ADDENDUM NO. 6

PROJECT: A1/A2 Reservoirs and B/C Booster Pump Station Project

CIP NO.: GW-0112

ISSUED: February 12, 2021

SHEET
C-111
OF

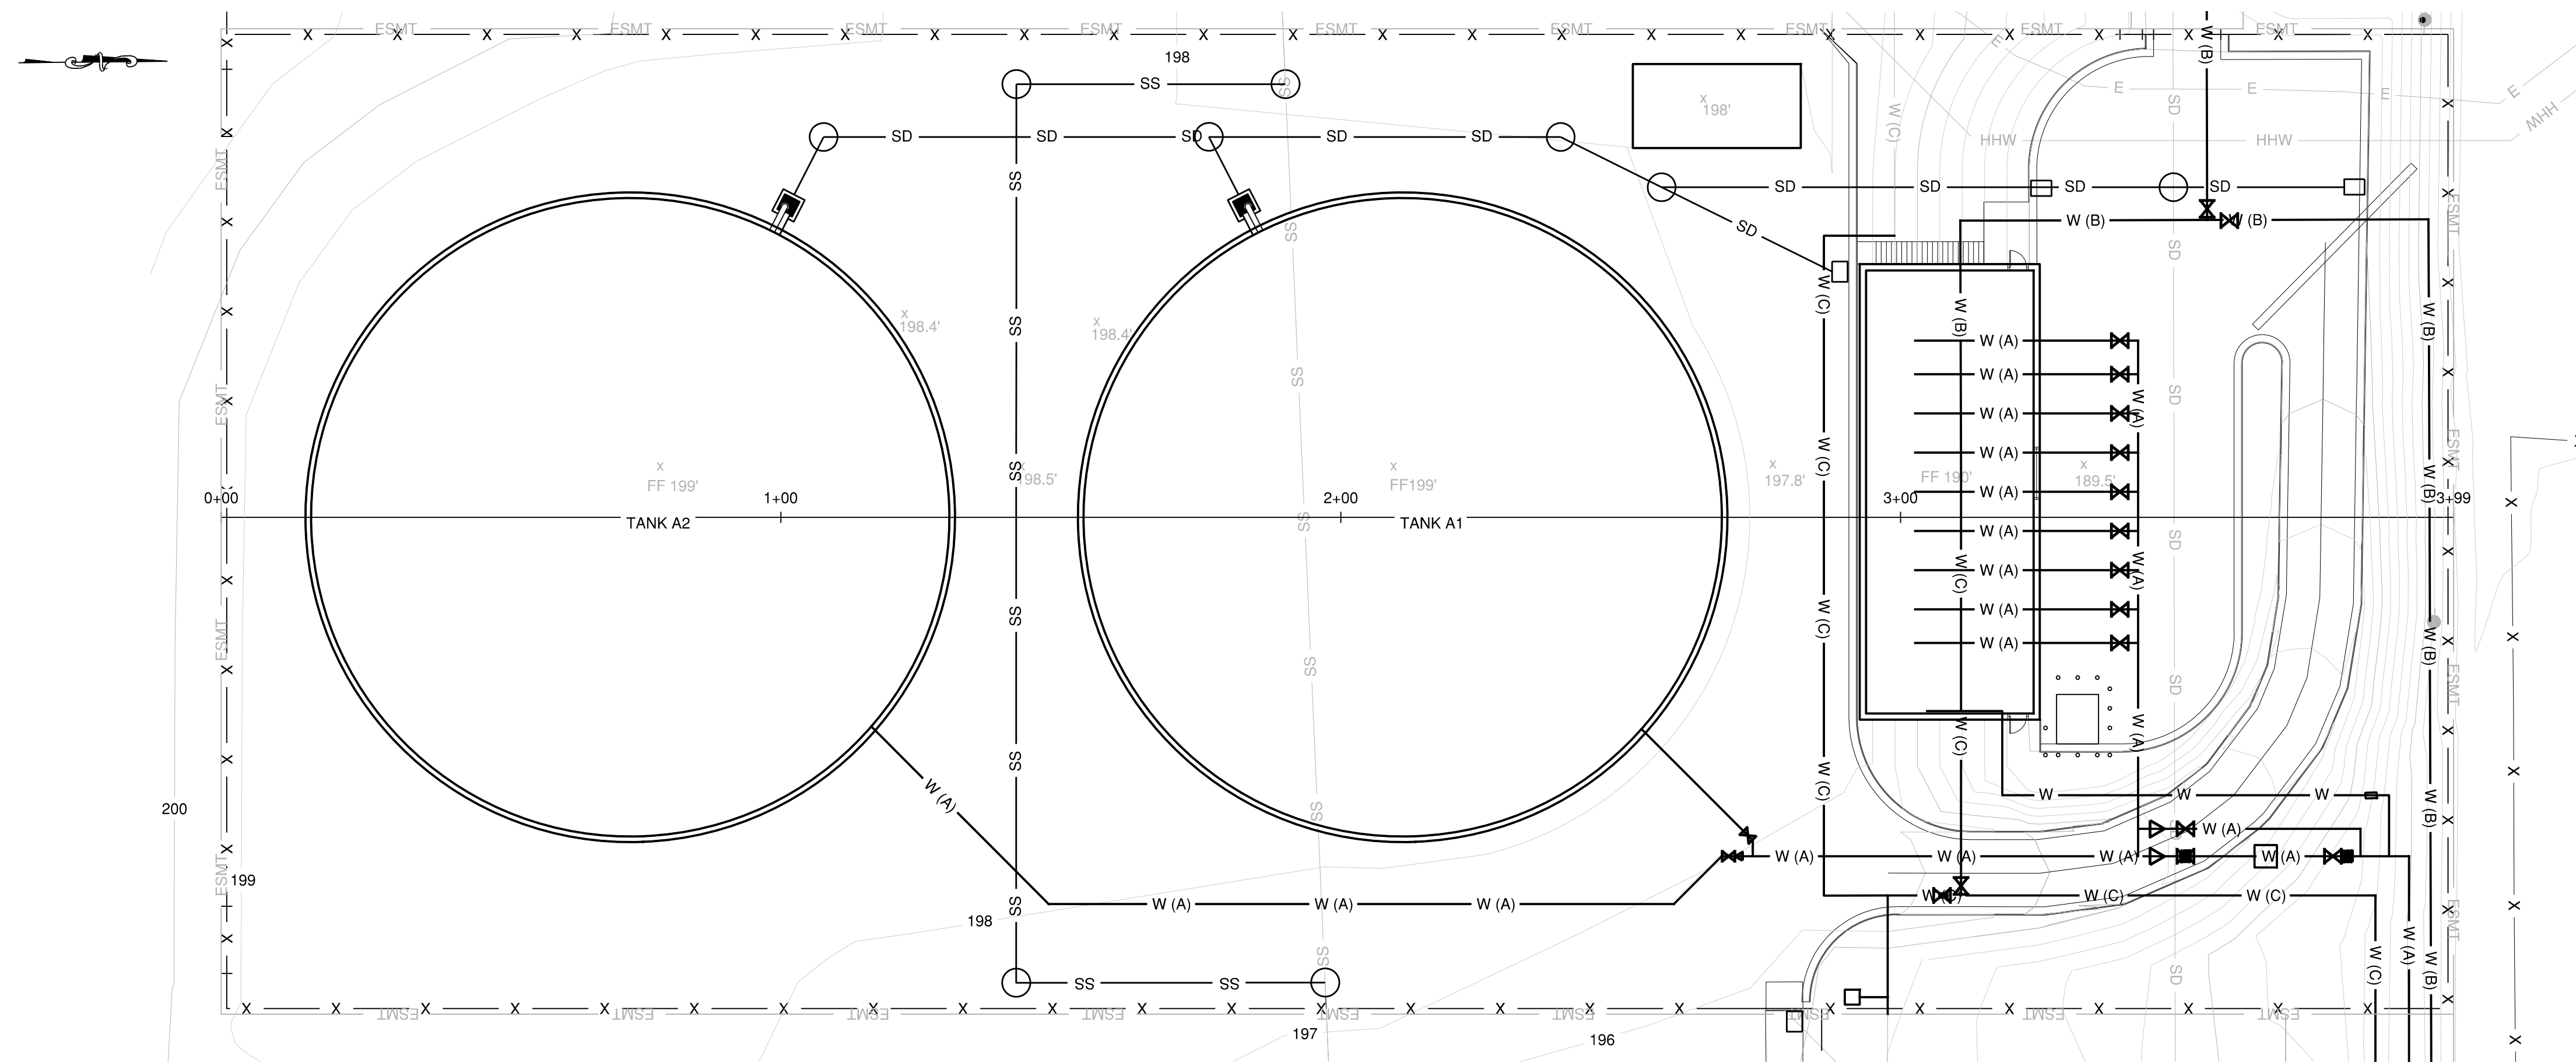
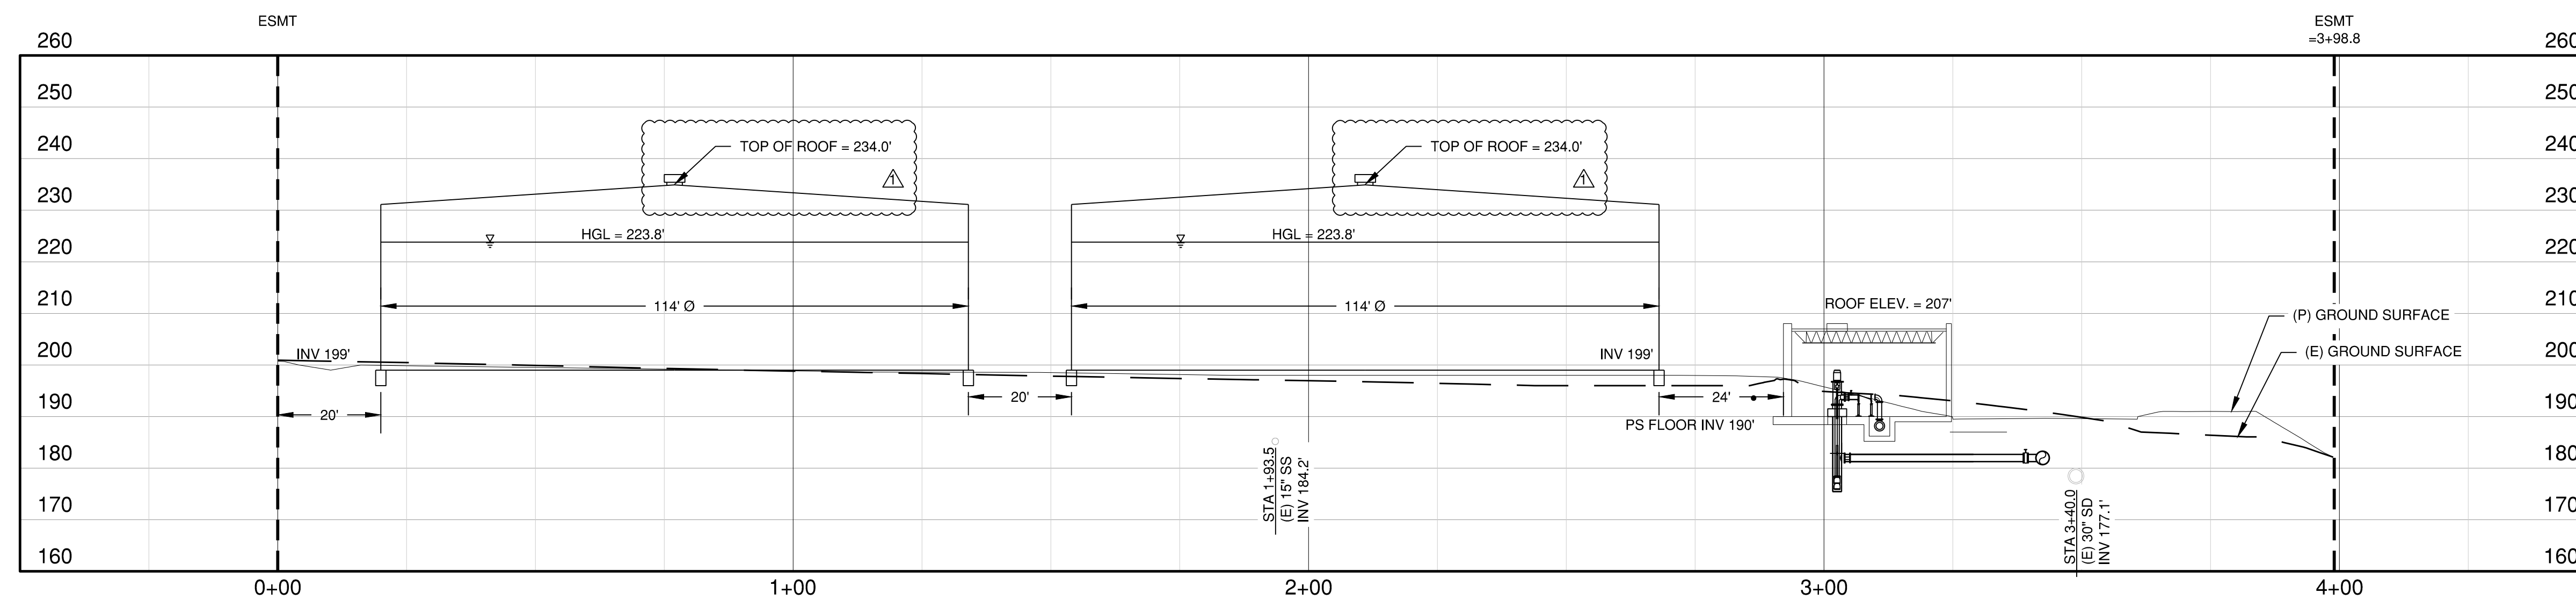
- D. Sheet C-111, is reissued revising the height of the tank callout (attached).
- E. Sheet C-112, is reissued revising the elevation of the tank shoulder in Section A (attached).
- F. Sheet S-10, Detail H, change the vertical dimension from 32.2 FT AFF to 31.2 FT AFF.
